COUNTY OF CHEMUNG
Chemung County Stormwater Coalition
851 Chemung Street
Horseheads, New York 14825
Ph. 607.796.2216

PROJECT: CDS Monarch
City of Elmira
Municipal Construction Inspection
May 3, 2018

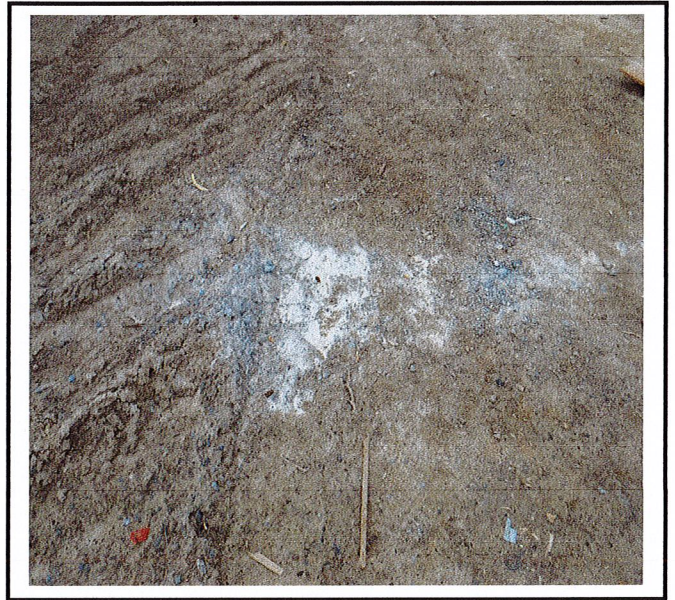
Runoff is getting under the compost sock at the north west end of the buildings.
